Site Address :
**NEW BREAKS FARM,
 SWINE FLEET,
 NR GOOLE,
 DN14 8DZ.**

Project:
PROPOSED BARN CONVERSION.

Drawing Title:
**PLANNING STATUS : SCHEME "B"
 PROPOSED GENERAL ARRANGEMENT OF
 SITE / FLOOR PLANS & ELEVATIONS.**

Drawing Number: Rev:
H.CON.04.22.03 C

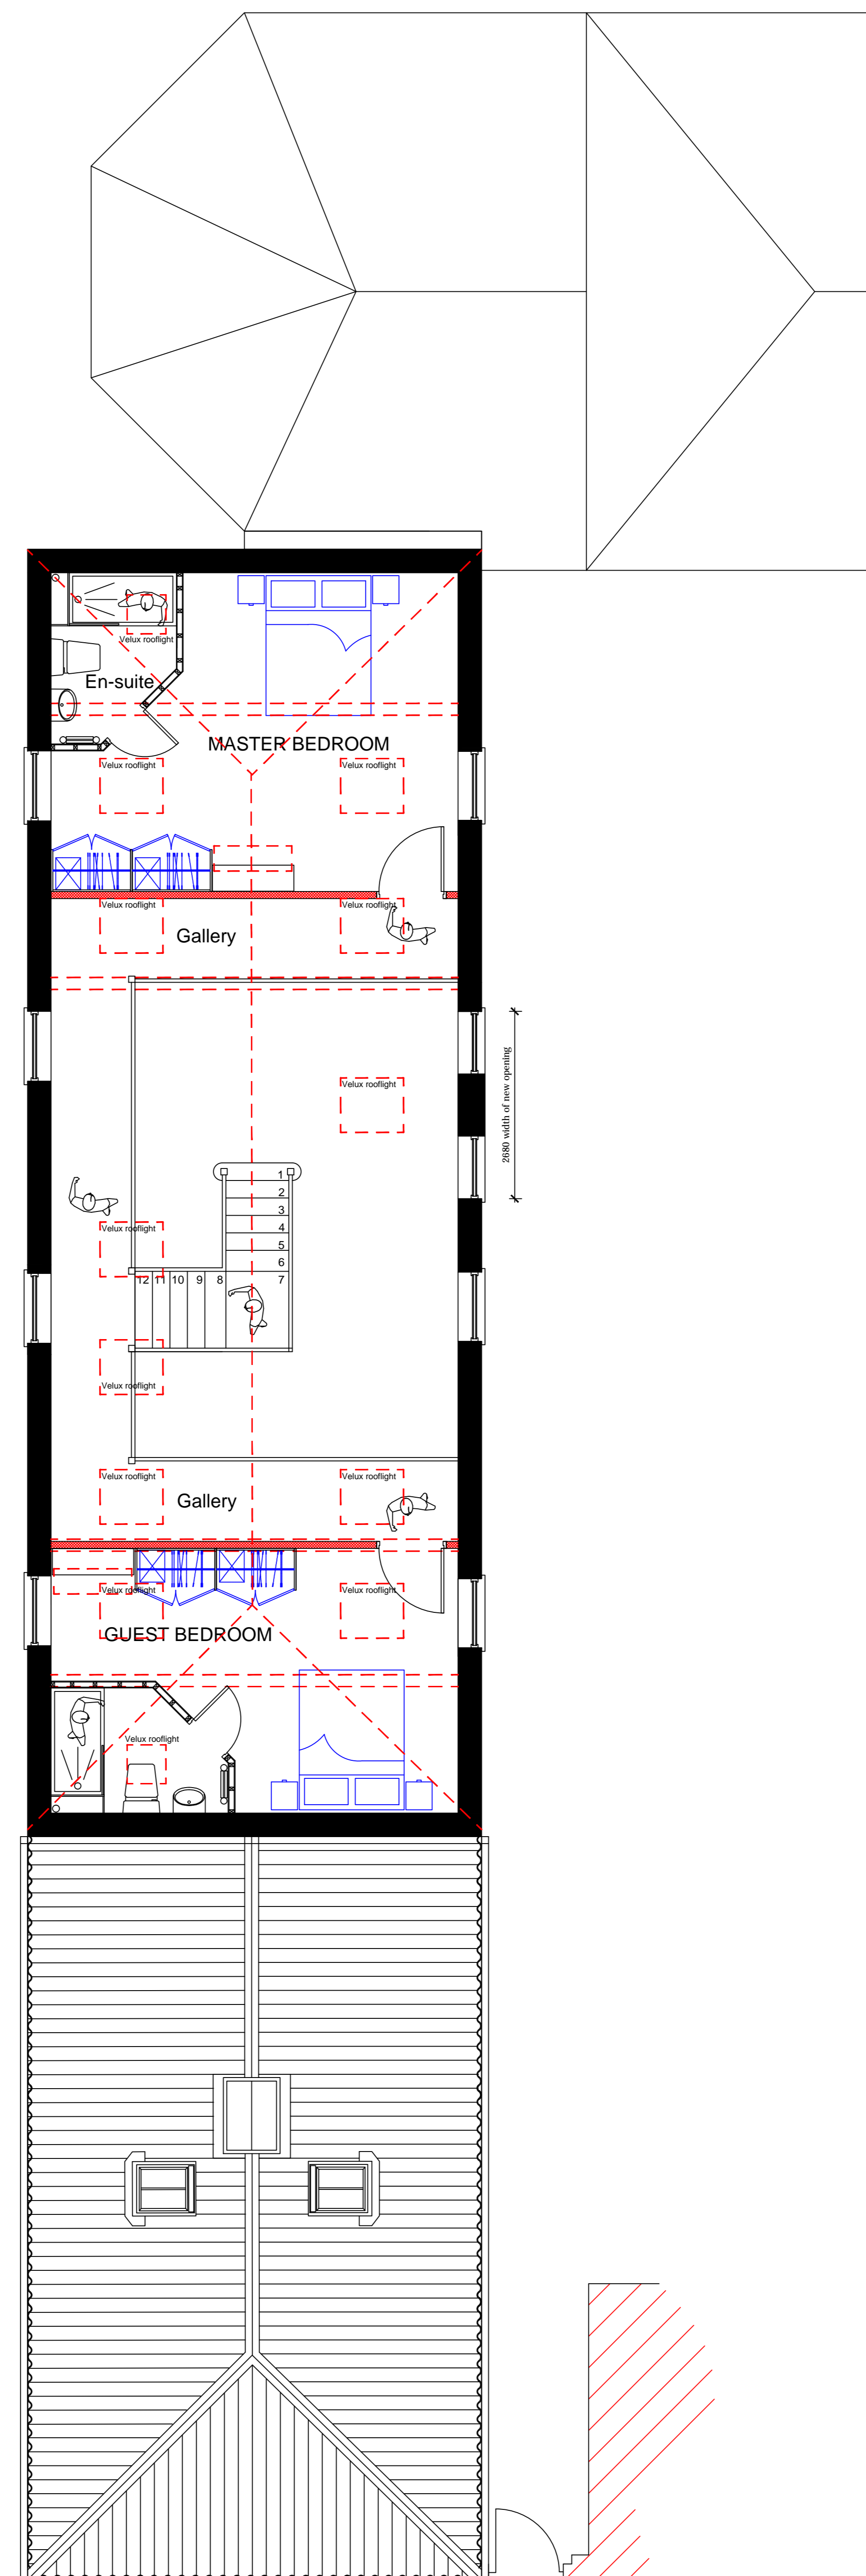
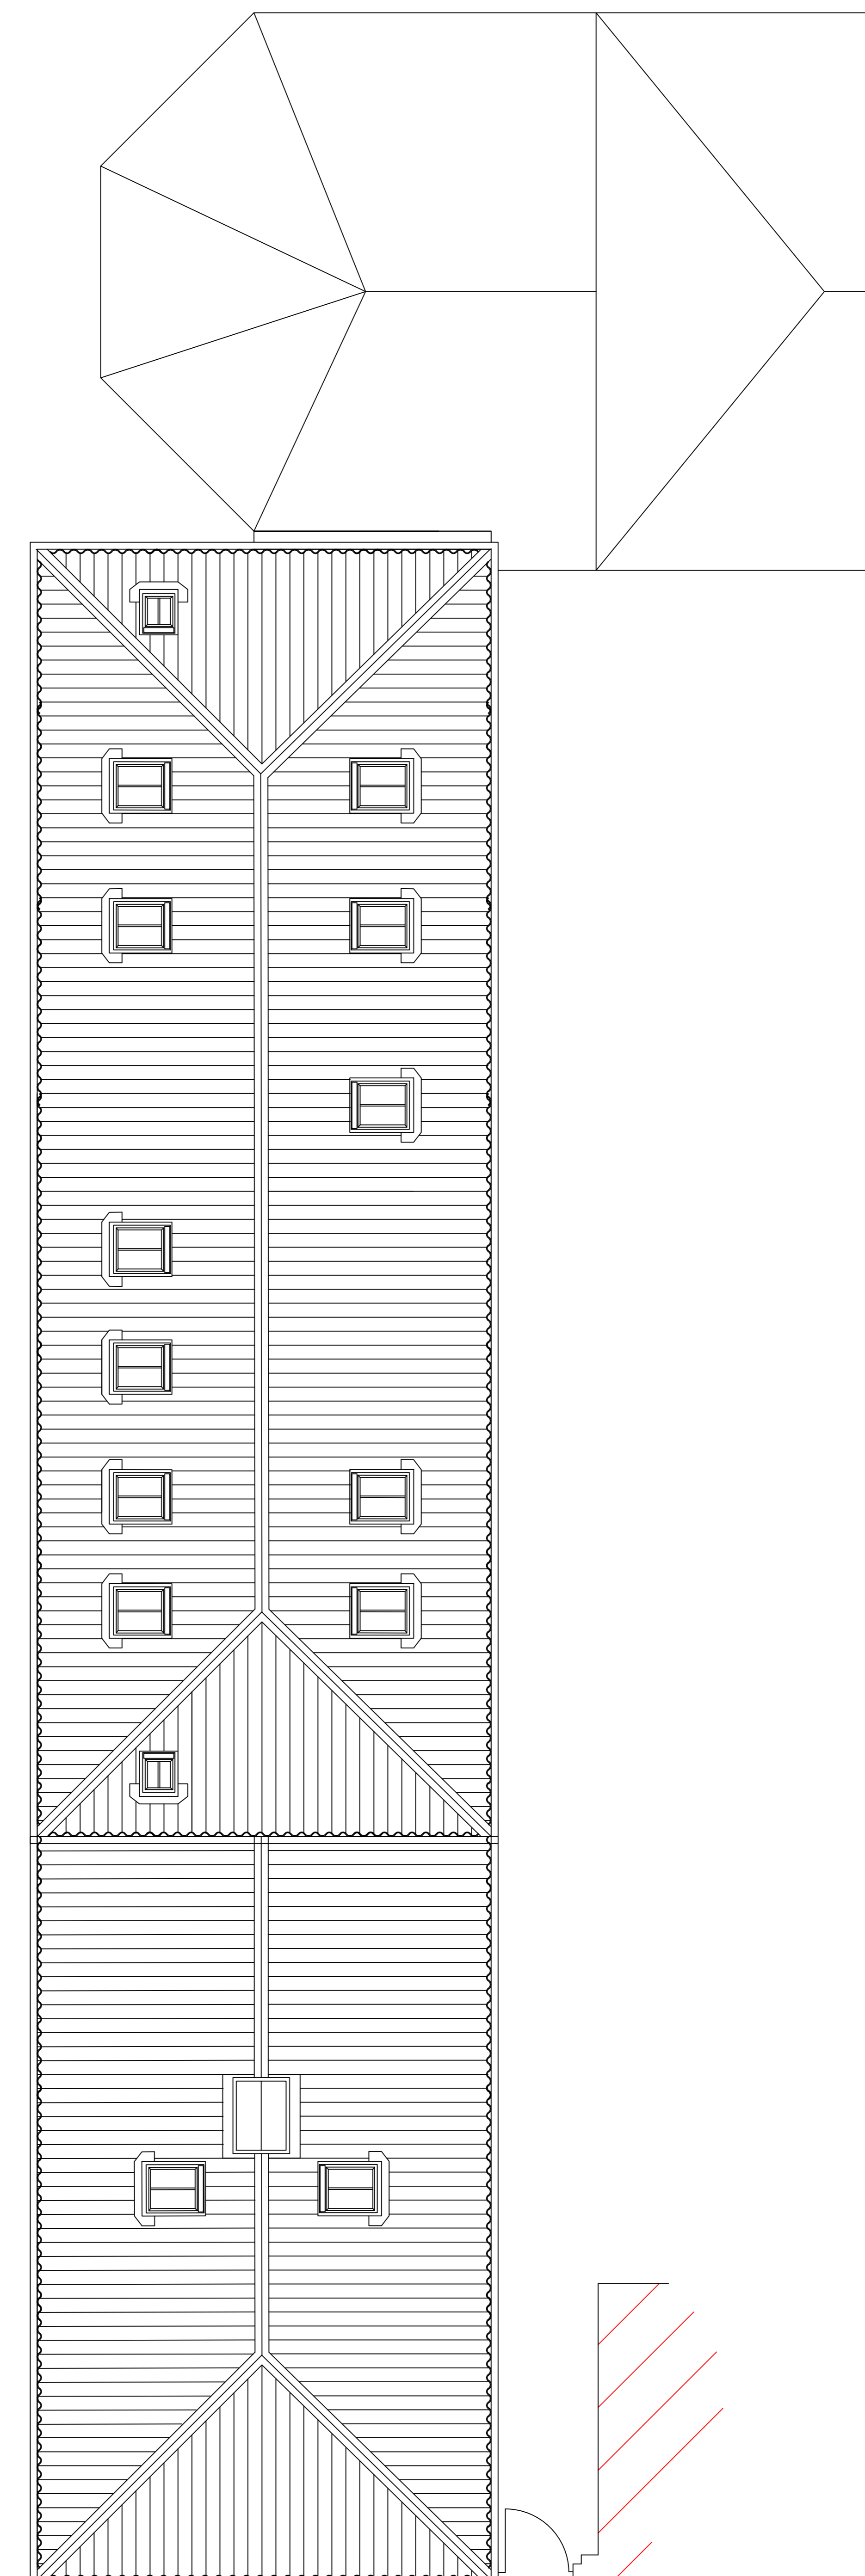
REVISION C' (NOVEMBER 2023)
 Drawing revised to illustrate amendments as recommended by conservation officers to include :-
 1. EAST ELEVATION :
 3 Windows above main entrance reduced to 2 with a sensitive break between both.
 Number of Conservation "Heritage" style Velux rooflights above main entrance reduced from 3 to 1 and Velux rooflights generally reduced in size to be proportional with slope of roof.
 2. WEST ELEVATION :
 Conservation "Heritage" style Velux rooflights reduced in number to 6 on main roof.
